LETTER OF TRANSMITTAL

DATE: July 12, 2012
 PROJECT: Sippo Creek Reservoir Dam
 JOB NO.: 13814498 (ODNR #0614-012)
 PROJ. MGR. Mike Damian
 RE: ODNR Comment Response Letter

**RE: Sippo Creek Reservoir Dam
City of Massillon, Stark County
Hydrologic and Hydraulic Report Comments Response
File Number 0614-012**

Lincoln Way Culvert Comparison Chart

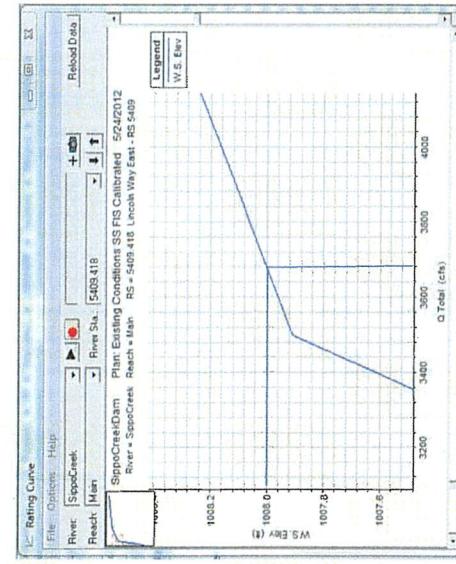
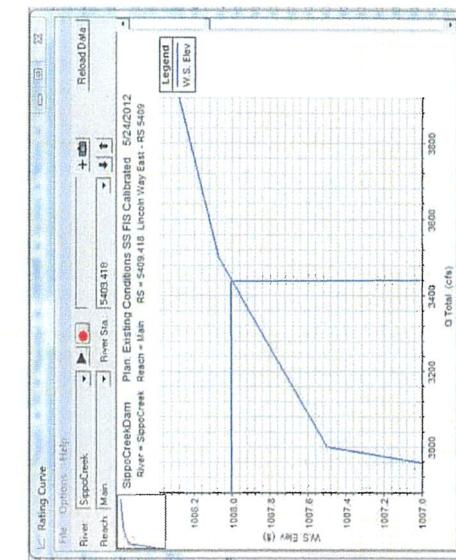
2. Page 2-15 states that the maximum capacity of the culvert is approximately 3500 cubic feet per second. Review of the energy grade line for cross section 5409 just upstream of the culvert indicates that the maximum capacity of the culvert is 3000 cubic feet per second. Please address this inconsistency.

The top of the Lincoln Way Road is at an approximate elevation of 1108.0. In the URS HEC-RAS model, a large entrance loss ($Ke=0.9$) was used to determine the maximum head expected upstream of the embankment, and the minimum capacity of the culvert. The actual entrance loss for the culvert is estimated to be between 0.2-0.4, as shown on the attached Lincoln Way Culvert Comparison Chart. The culvert is an arch box, with 30-75° wingwalls, and square crown. The crown has become rounded by spalling. The actual entrance loss into the culvert is a best estimate. In the HydroCAD model, a much lower entrance loss (0.2) was used to minimize storage behind the embankment, to remain conservative. Using the higher entrance loss in the HEC-RAS model determines worst-case upstream flooding depths. Using a lower entrance loss in the HydroCAD model prevents increased storage from lowering the discharge downstream. Using a conservative Ke value of 0.5 for the culvert, in the HEC-RAS model, shows it has a capacity of approximately 3,350 cfs (see attached Lincoln Way Culvert Comparison Chart). Using an entrance loss value of 0.2 in the HydroCAD model indicates that the capacity of the culvert is approximately 3,480 cfs as shown in the Lincoln Way Culvert Comparison Chart. Using an entrance loss this low in the HEC-RAS model overestimates the capacity of the culvert.
